SEISMIC WALKDOWN CHECKLIST FORM

IP3

Seismic Walkdown Checklist (SWC) SWEL1-092

Equipment Description CC SURGE TANK #31

**Note:** Typical anchor bolt detail

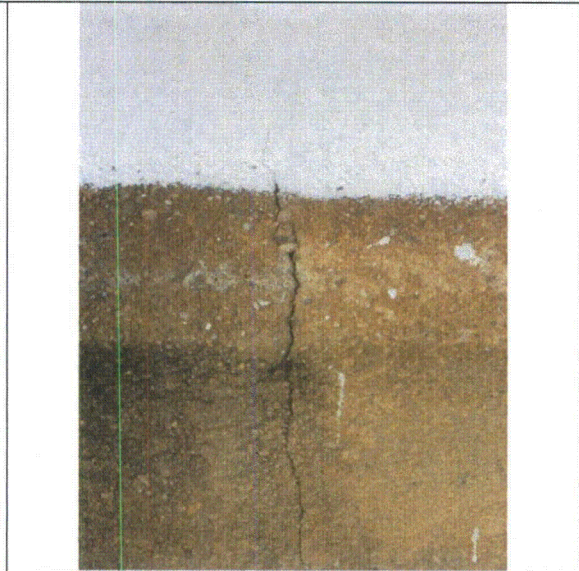
**Note:** Crack profile at location intermediate between anchor bolts. Note that the crack continues through the coating indication that the crack has been active since the coating was applied.

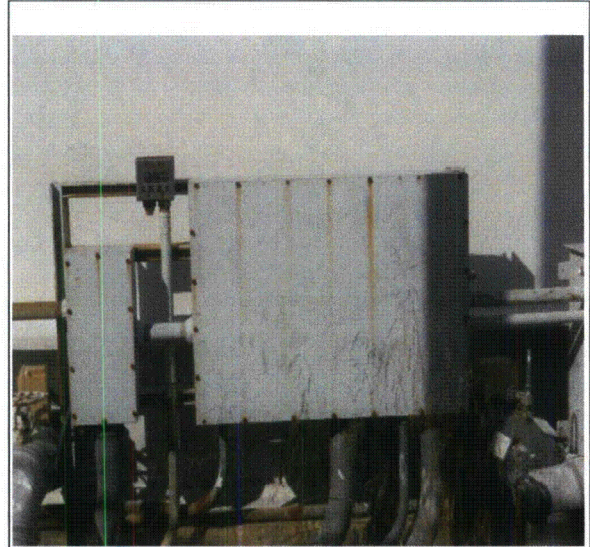
**Note:** *Pipes which span the height of the tank without intermediate support.*

**Note:** *Cabinet which is missing bolts in face plate.*

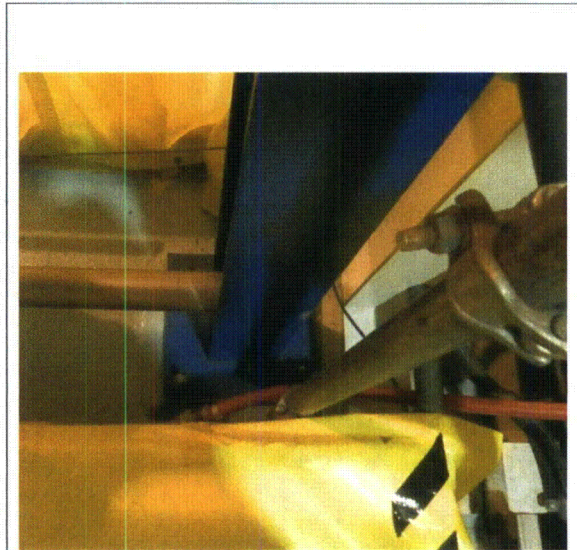
**Note:** base plate with 3 additional bolts.

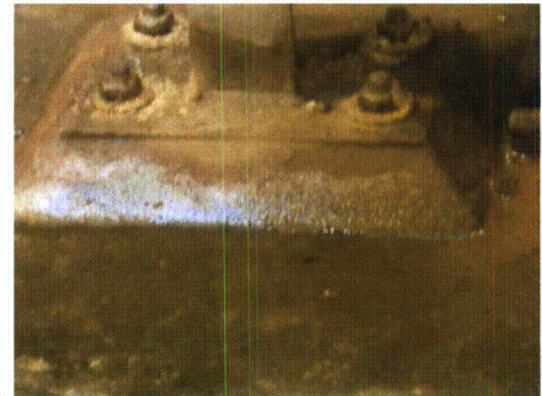
<p><b>Note:</b> Control Panel TWS #31</p>	<p><b>Note:</b> Missing three anchor bolts</p>

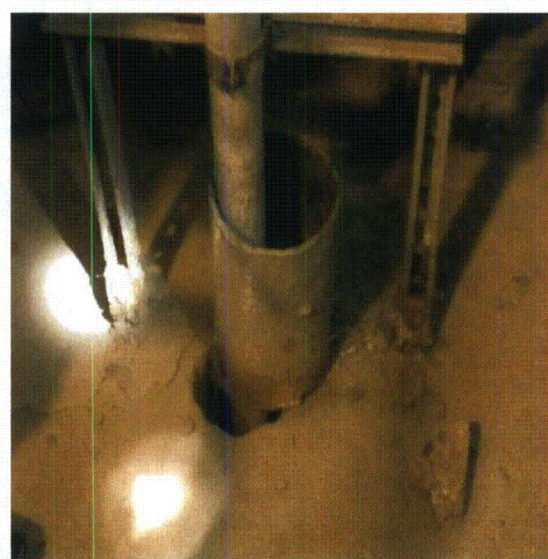
**Note:** Corroded and broken Unistrut near door.

**Note:** Corroded and broken Unistrut near door and a loose pipe protection cover between the Unistrut legs

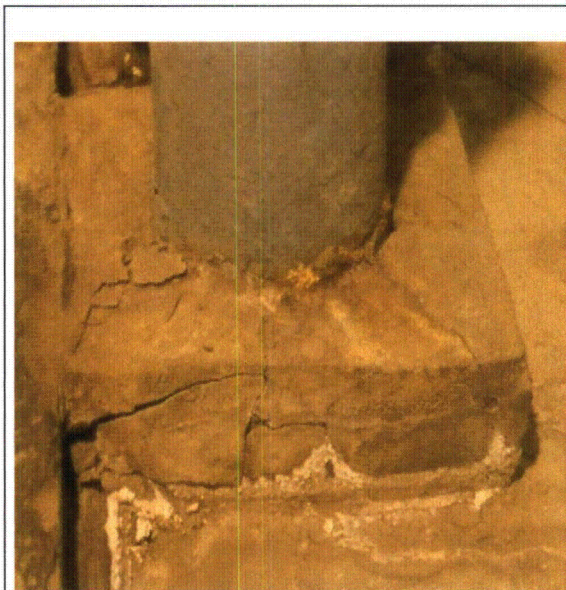
**Note:** Cracked grout penetration protection

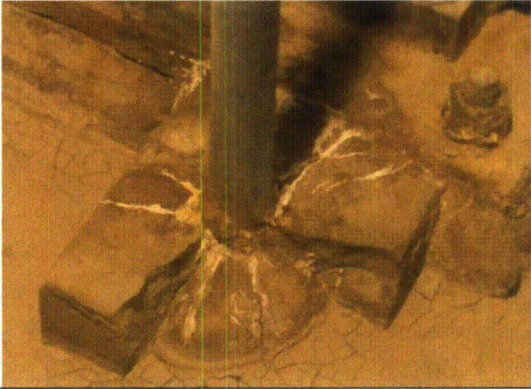
<p><b>Note:</b> Cracked and chipped grout penetration protection</p>	<p><b>Note:</b> Cracked and chipped grout penetration protection</p>

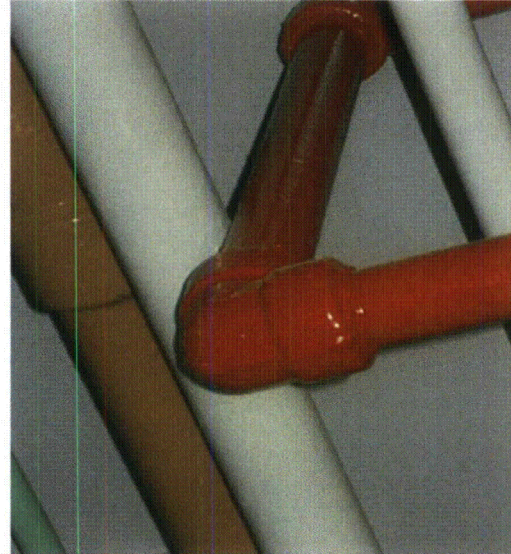
**Note:** Pipe support with only 4 bolts installed and 2 empty bolt holes.

**Note:** Fire water line in close proximity to a conduit.

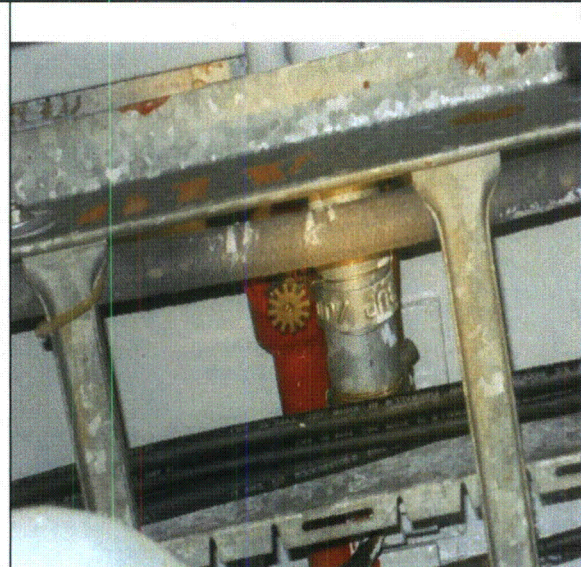
**Note:** Fire water line in close proximity to a conduit.

**Note:** Sprinkler head in close proximity to adjacent conduit.

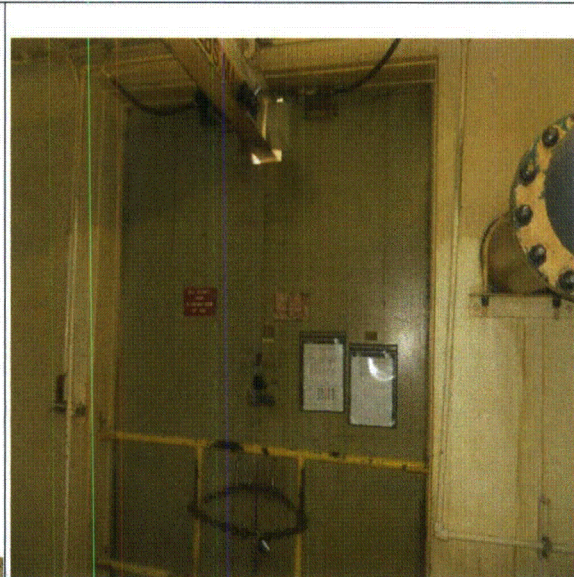
**Note:** Pipe insulation interference with structural steel.

**Note:** Air line at Door 218

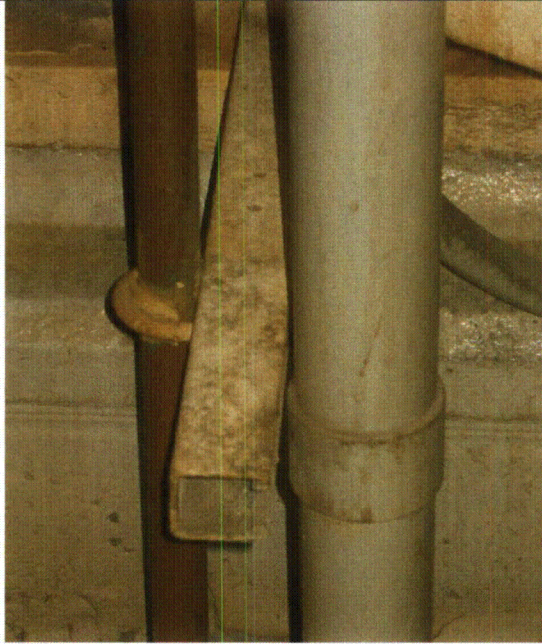
**Note:** The connection of the conduit riser next to column H8/19.5 is missing the U-bolt attachment to the Unistrut.

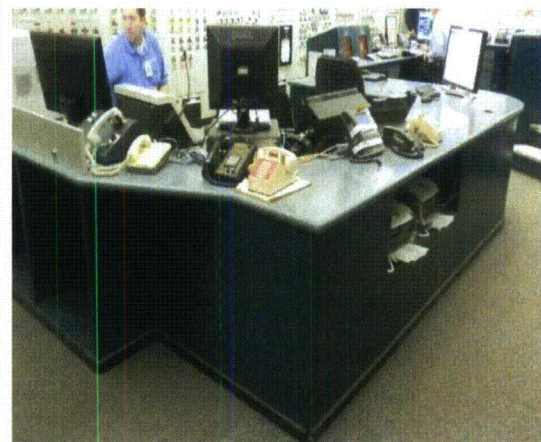
**Note:** Rack adjacent to Instrument Bus 31 has an unrestrained laptop and printer

**Note:** Boxes against the west wall on the floor and a box resting on top of a cabinet at the northwest corner of the room

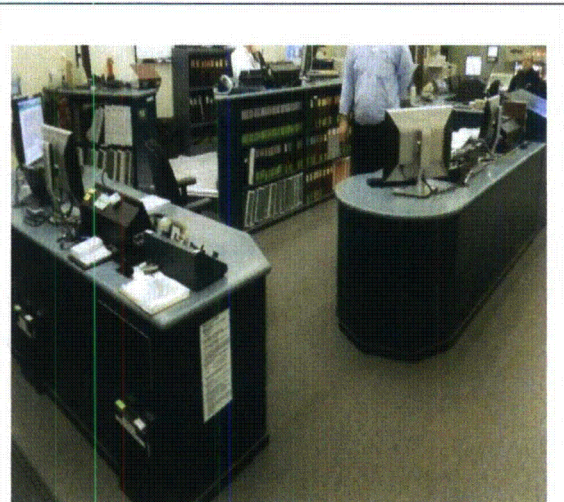
**Note:** Unrestrained speaker on top of 34 Control Room Supplemental Cooler along the south wall

**Note:** Unrestrained phones, printers and monitors at work stations

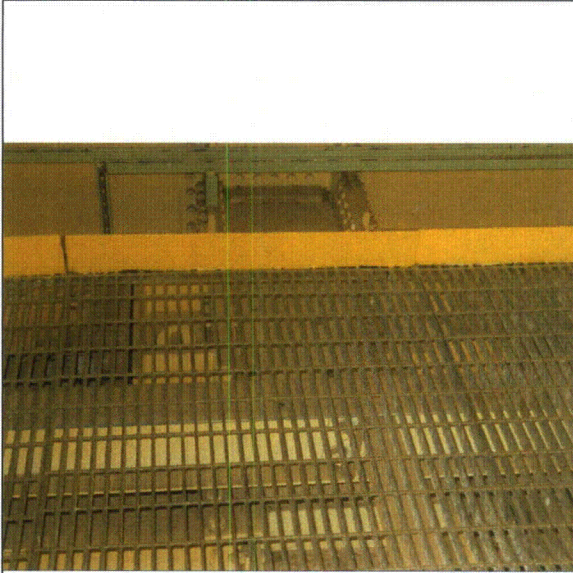
**Note:** Some sections of grating are not attached to the steel beam below.

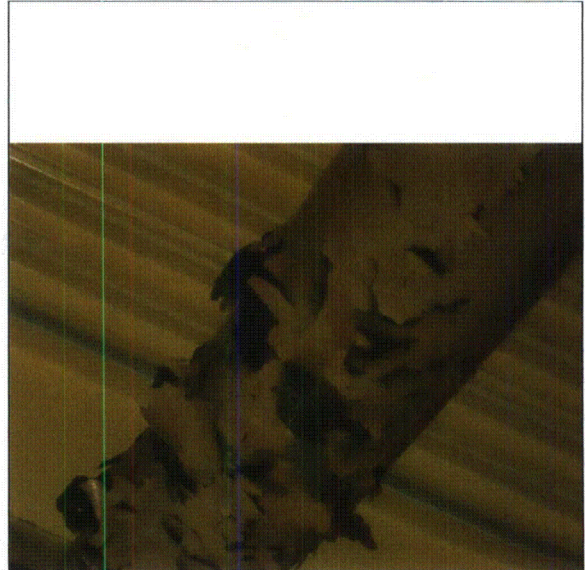
**Note:** Some fluorescent bulbs near south end of the platform are out and need to be replaced.

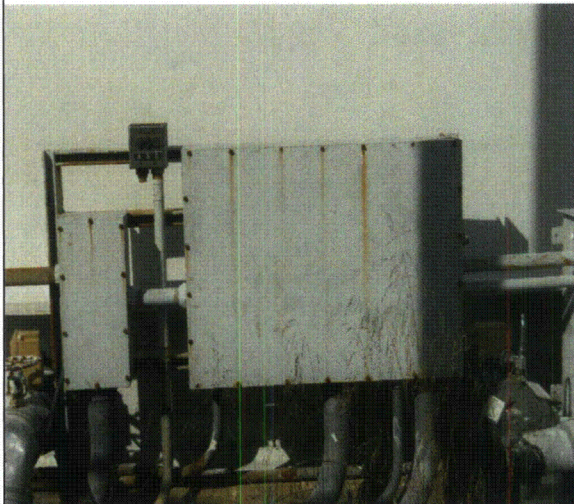
**Note:** Several screws are missing for the electric panels

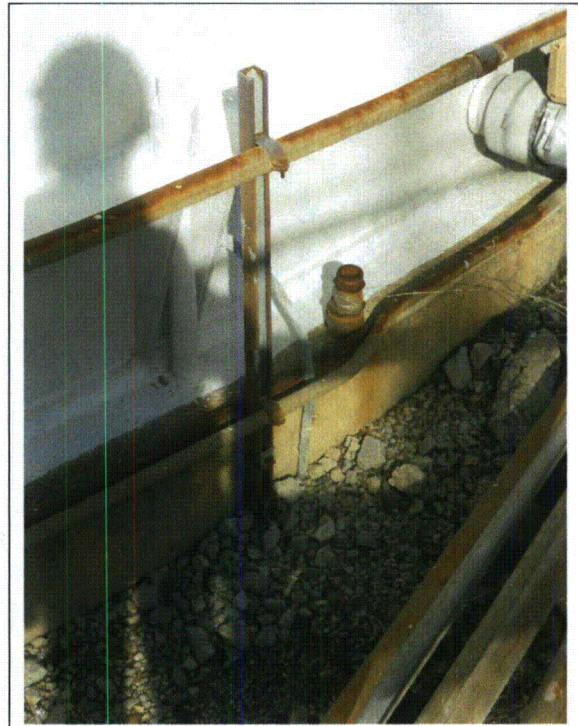
**Note:** *All the conduit and pipes show sign of various stages of corrosion.*

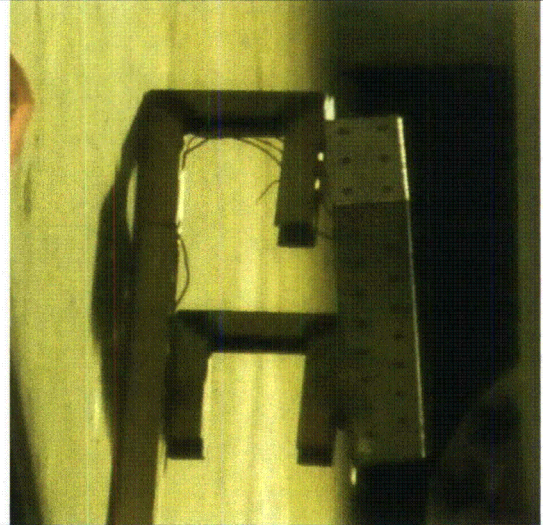
**Note:** Gap between the base plate and wall.

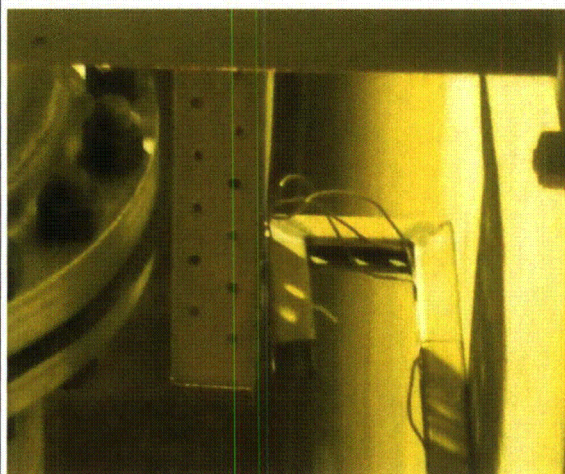
**Note:** Gaps between wire trough and Unistrut looking south.

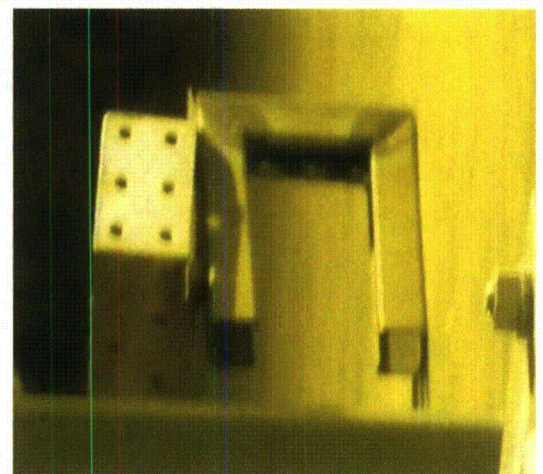
**Note:** Gap between wire trough and Unistrut looking north.
